G3NO-2008-00005

DOCKET: No. 52-024

SUBJECT: Responses to NRC Requests for Additional Information, Letter No. 6
(GG3 COLA)

REFERENCE: NRC Letter to Entergy Nuclear, *Request for Additional Information
Letter No. 6 Related to the SRP Section 10.04.05 for the Grand Gulf
Combined License Application*, dated September 18, 2008 (ADAMS
Accession No. ML082620605)

Figure RAI 10.4.5-3-2 Site Drainage Schematic

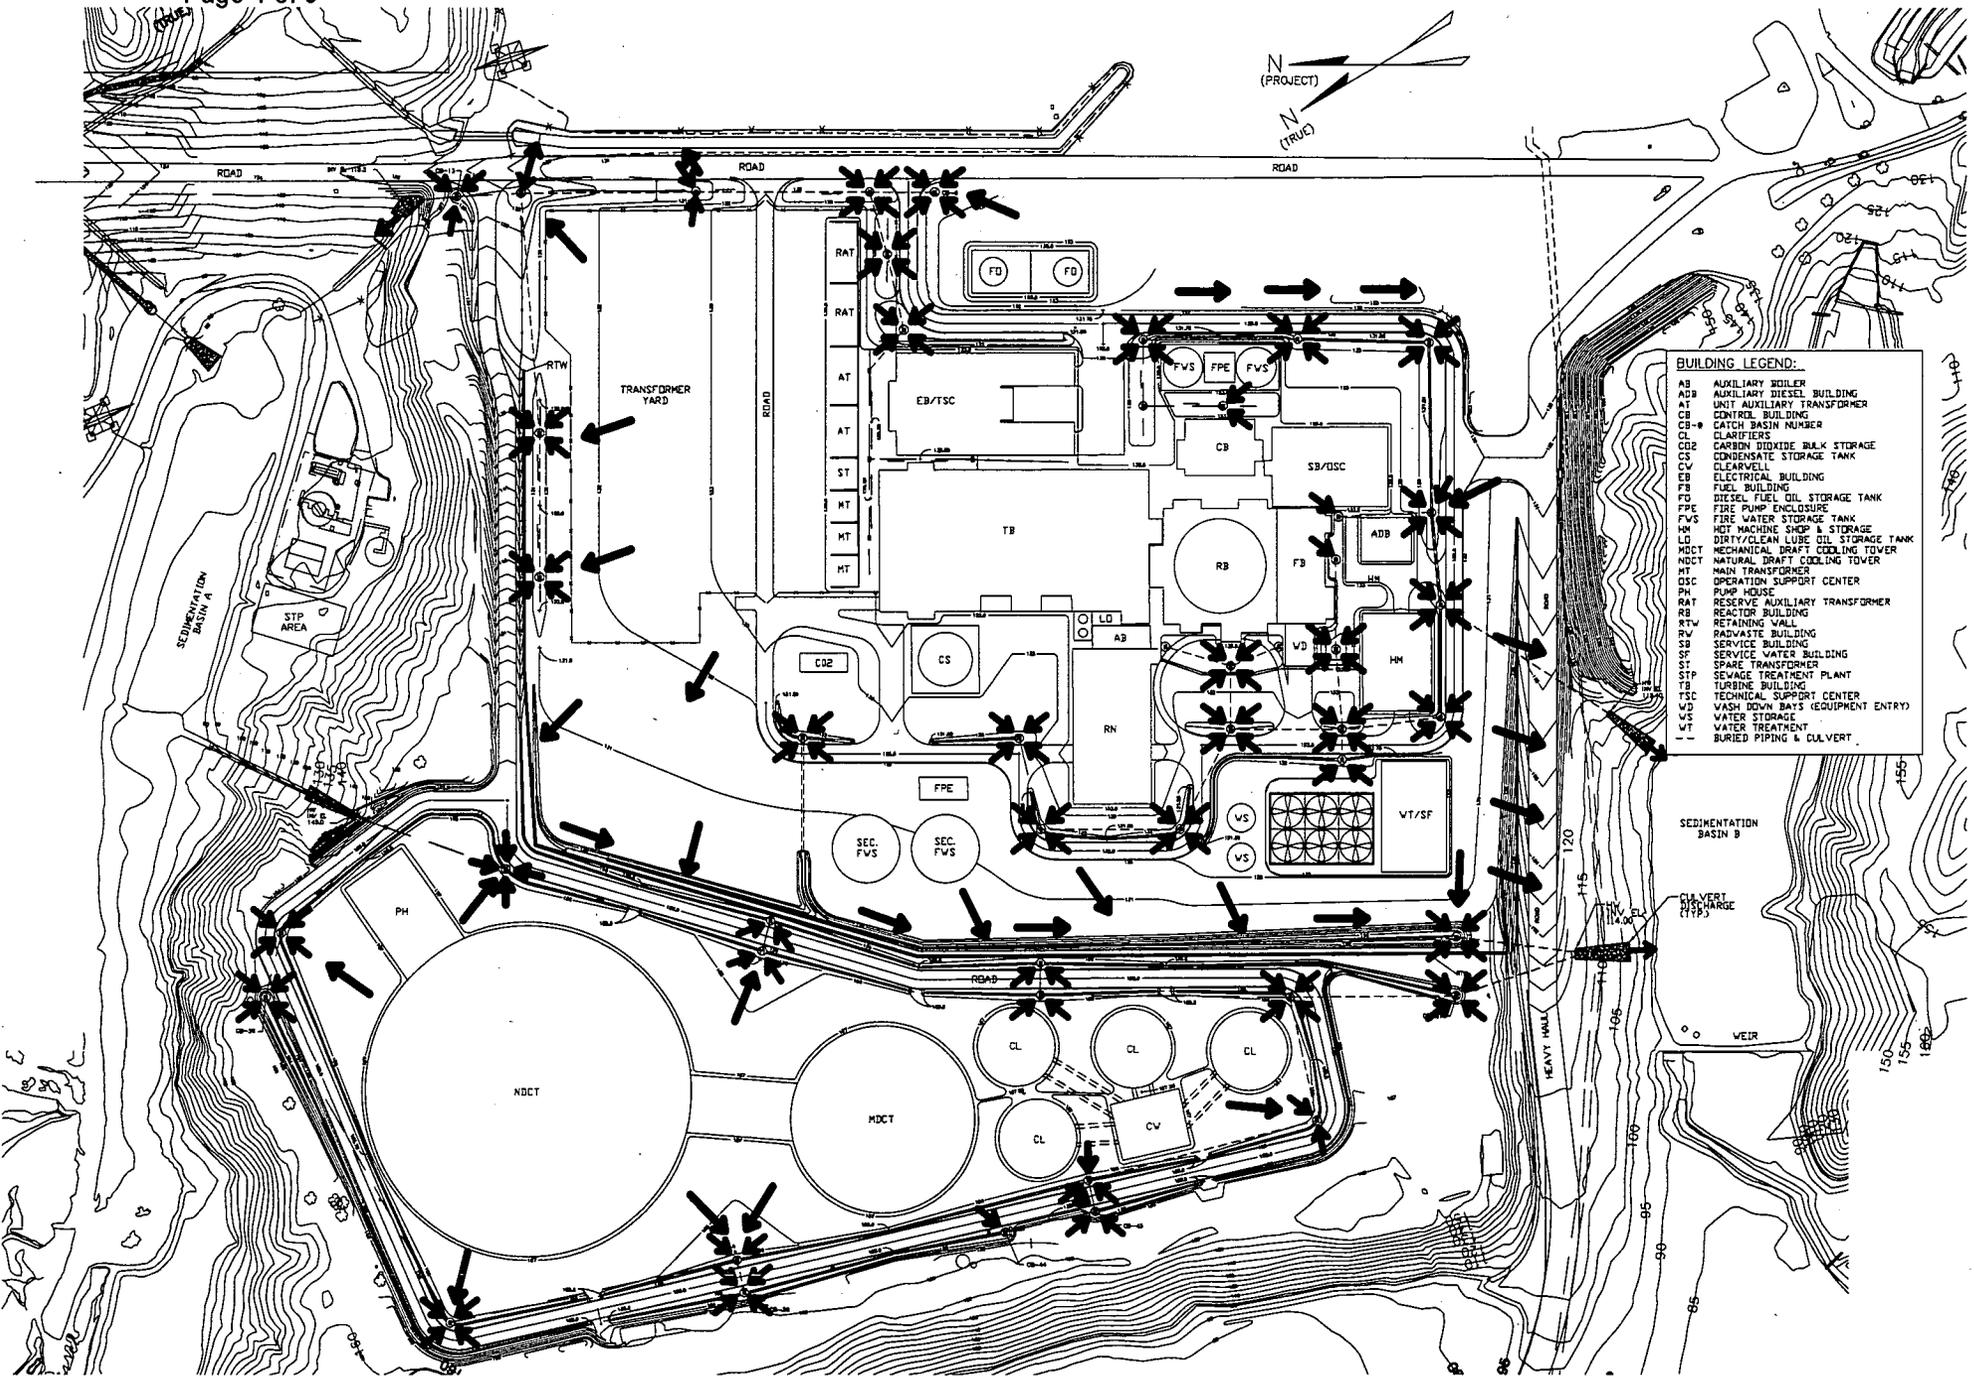
In Grand Gulf Nuclear Station (GGNS) FSAR Section 10.4.5.8, "Normal Power Heat Sink," the applicant described the GGNS site-specific normal power heat sink which consists of two cooling towers, one natural draft (NDCT) and the other mechanical draft (MDCT) tower. The applicant stated that the NDCT would be located at a distance equal to its height 168 m (550 ft) away from Seismic Category 1 and 2 structures, and therefore there is no potential for the cooling tower to fall or damage safety-related structures or components. Regarding the MDCT, it has multiple fans with associated motors, couplings and gearboxes. These fans rotate at relatively slow speed and the fan blades are made of relatively low-density material. The applicant stated that a failure of a fan could result in the generation of missiles; however, the applicant concluded that due to the location of the MDCT and the materials used in the construction of the MDCT any damage would be confined to the MDCT itself.

The staff reviewed the information provided by the applicant in FSAR Section 10.4.5.8 and could not find further details on the location of the MDCT. Also, the staff could not find any design features to prevent or control the flooding effects in case of a cooling tower failure (i.e., missile generation) on the nearby safety-related areas and/or the safety-related SSCs as they relate to the requirements of GDC 4 criteria. Also, no information is provided in the COLA with respect to Section 10.4.5.6, "Flood Protection," of the ESBWR DCD, Revision 4. In accordance with SRP Section 10.4.5, "Circulating Water System," Item II.1, design provisions need to be provided to accommodate the effects of discharging water that may result from a failure of a component or piping in the CWS. Therefore, the staff requests that the applicant provide additional information regarding its cooling tower failure analysis or the provisions that are incorporated in the GGNS CWS design to prevent unacceptable flooding of areas containing safety-related equipment or to mitigate the consequences of flooding.

Figure RAI 10.4.5-3-2 shows the drainage patterns for the power block area; all areas around the power block being graded and sloped to provide drainage away from the power block structures. On the north side of the site, water would flow toward the drainage ditch on the east side, or to the west into the drainage ditch along the retaining wall and on to Stream B and/or the heavy haul road south of the unit. Water on the west side would flow to the west and south either through the drainage system to Stream B or overland to the heavy haul road. Water reaching the heavy haul road would flow down the road toward the river or into ditches on each side of this road. Water on the east side of the site would flow into drainage ditches and catch basins and flow to the north or the south away from the power block structures.

Therefore, as required by GDC 4, safety-related SSCs would not be subjected to flooding as a result of a failure of the NDCT cooling tower basin or other CIRC piping or components.
